U.S. ROUTE 40/61 BRIDGE OVER THE MISSOURI RIVER
ST. CHARLES AND ST. LOUIS COUNTIES, MISSOURI
MoDOT JOB NO. J6P1436

FINAL ENVIRONMENTAL IMPACT STATEMENT

**Figure 3-1
Potential
Environmental Issues**

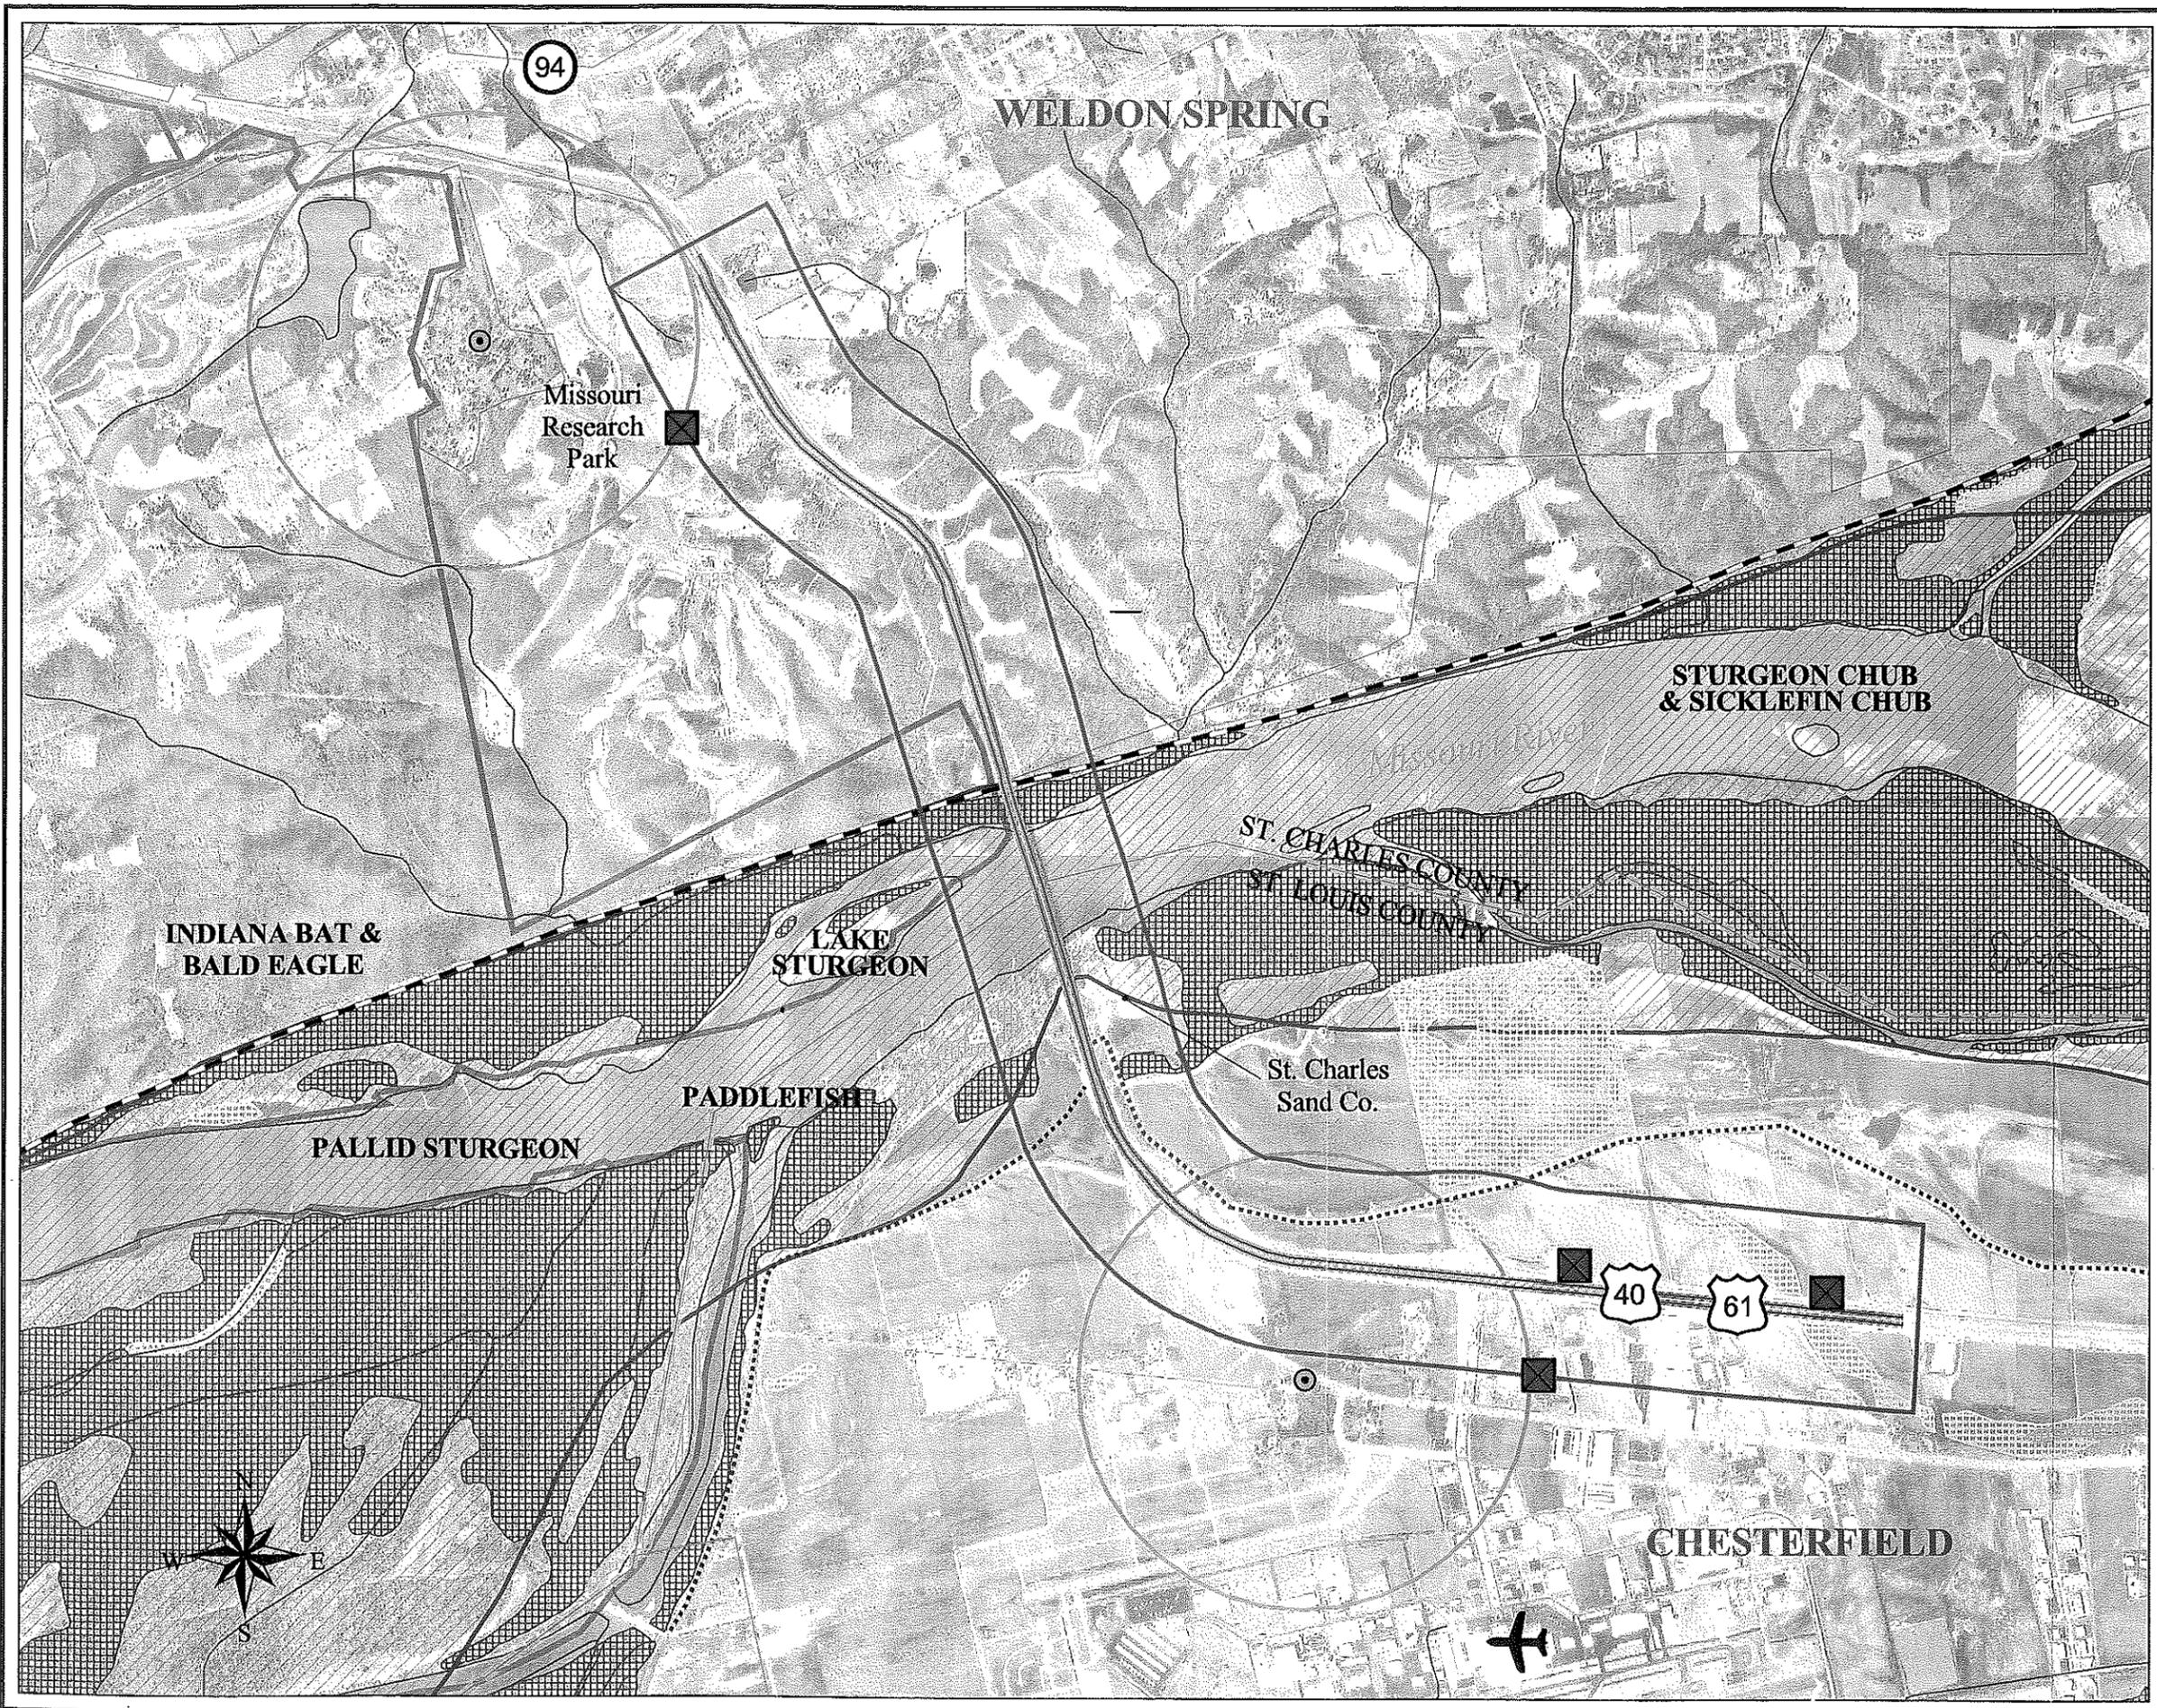
Figure 3-1 shows four (4) potential hazardous waste sites in the project area and Section 3.0 states that these sites are unconfirmed database sites obtained from a nonspecific search of related facilities. Later in the document, Section 4.17 states that the only hazardous waste site identified within the project area is associated with petroleum spills and/or releases into the Missouri River, but the four potential sites are not discussed. We recommend including a discussion of further investigation, or site analysis that determines if the four potential sites exist, and if so, do they present any project-relevant environmental issues.

Figure 3-1 shows palustrine emergent (PEM) wetlands located near the existing roadway on the east end of the project area, but the document does not specifically discuss the approaches and roadway modification that will be required to connect the existing roadway to the new bridge configuration. Please include a discussion of the extent of the roadway modification and its effects on these wetlands and any other environmental impacts associated with the new alignment.

Section 3.0 has been modified in response to the recommendation for further information on four potential hazardous waste sites depicted in Figure 3-1.
